**NSLPP MEETING HELD ON 7/02/24****Attachments:**

ADDRESS/WARD: 9 Gundimaine Avenue, Kurraba Point**APPLICATION NO:** DA 381/22**PROPOSAL:** Alterations and additions to an existing detached dwelling including a first floor addition and a double garage**PLANS REF:**

OWNER: Catherine Louise Mary Stevens**APPLICANT:** Felicity King, Studio Barbara**AUTHOR:** Report of Robin Tse, Senior Assessment Office**DATE OF REPORT:** 18 January 2024**DATE LODGED:** 8 December 2022**RECOMMENDATION:** Refusal

Figure 13: Proposed building height

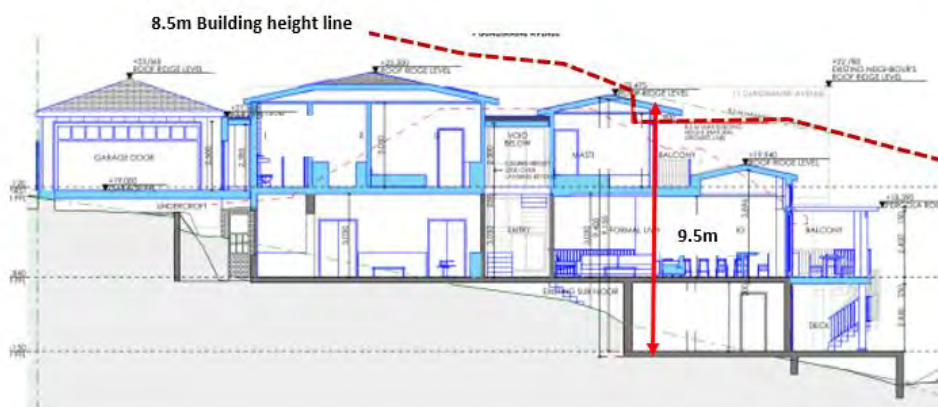
The proposed works would have a maximum height of 9.5m that fails to comply with the permissible height limit of 8.5m in accordance with clause 4.3 in NSLEP 2013 (**Figure 13**).

- (1)(a) To promote development that conforms to and reflects natural landforms, by stepping development on sloping land to follow the natural gradient** – The proposal generally respects the existing landform with a stepped built form on the eastern side of the main dwelling.
- (1)(b) To promote the retention and, if appropriate, sharing of existing views** - The building elements in breach of the LEP building height limit would primarily be the roof over the new master bedroom on the eastern end of the proposed first floor addition (**Figure 13**).

Figure 21: Foreshore building line and footprints of existing buildings

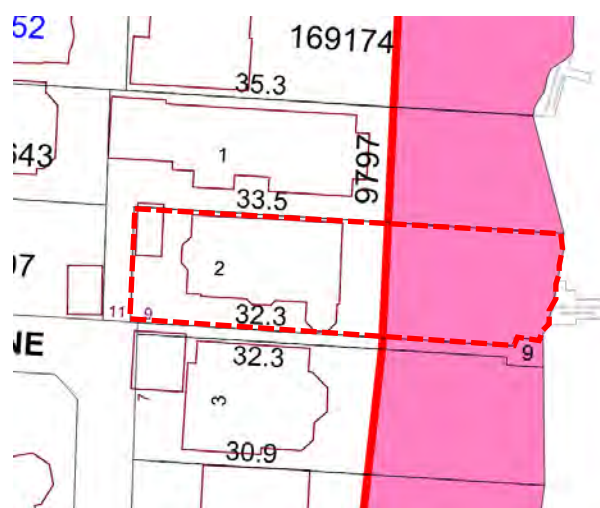
It is considered that the proposal would not offend the relevant provisions under Clause 6.9 in NSLEP 2013 because the proposed building works would be carried out primarily to the main dwelling away from the foreshore area.

Figure 2. Comparison of height measurement from a long section (source: Studio Barbara)

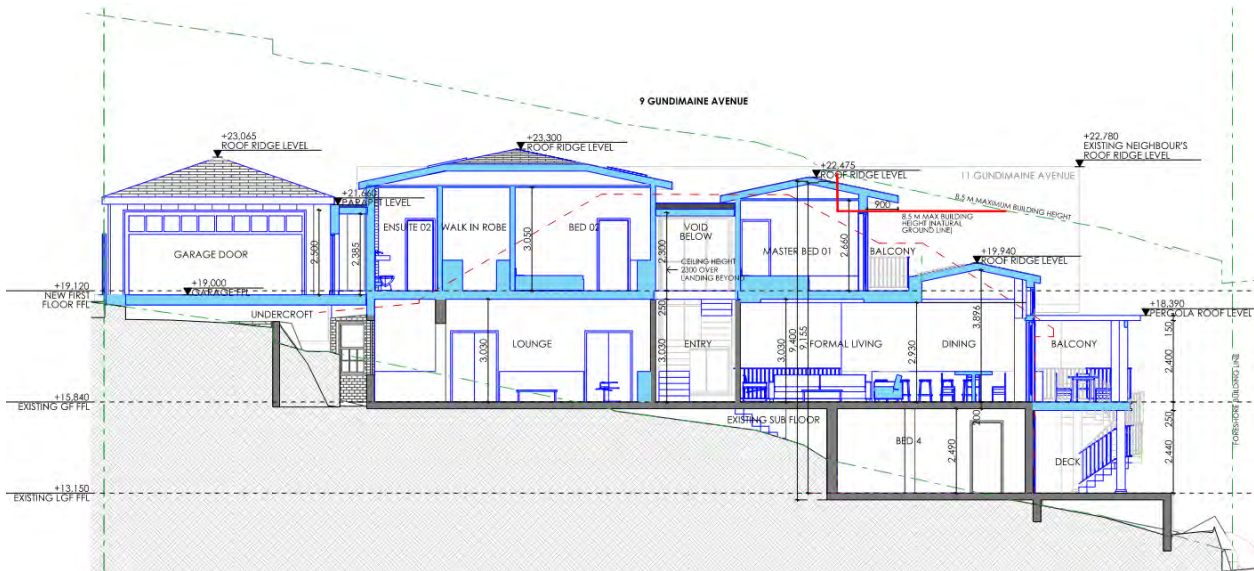
The majority of the building form and roof line complies with the height limit as demonstrated in Figure 2. In fact, the front portion of the building to the street is significantly under the height standard and reads as a 5.58m height when measured from the street level. The volume under the height control is much greater than the building volume greater than the control.
